19 April 2022

**APPLICATION: PLANNING APPLICATION PA2201534**  
**THE LAND: LOTS 39-41 ON PLAN OF SUBDIVISION 3732**  
**& LOT 1 ON TITLE PLAN 851238E**  
**(1-2, 4 LONG ISLAND DRV & 35 CEMETERY RD. HASTINGS)**  
**COMMUNICATION: S.54 RESPONSE & S.50 APPLICATION AMENDMENT**

Image: Extract of Figure 2 within the Native Vegetation Assessment (Rev 1.2)

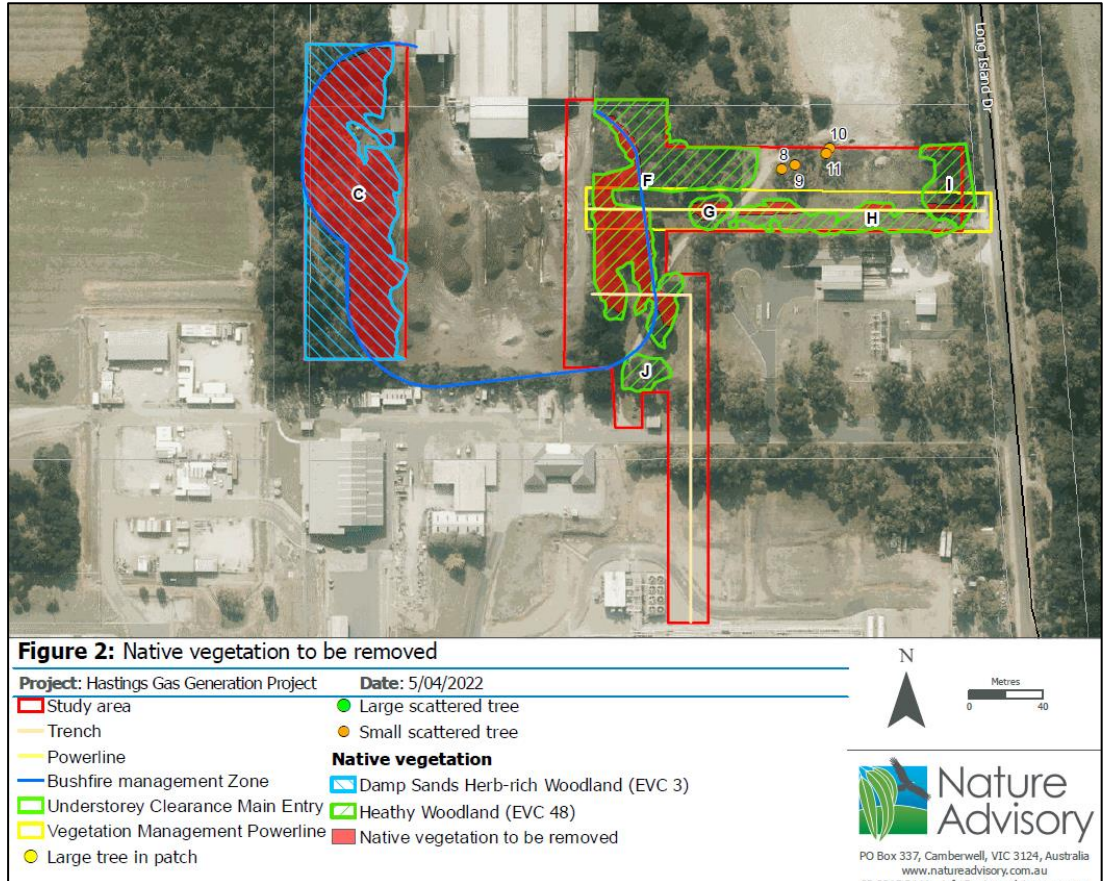
- a) Identification of any existing native vegetation along the proposed pipeline alignment.
- b) Clarification about whether any native vegetation is required to be removed to facilitate the proposed pipeline and connection infrastructure at the LIP facility

It is understood that additional native vegetation will result from the proposed infrastructure works, as illustrated at Figure 2 within the Assessment, see area F where it meets the proposed trench works.
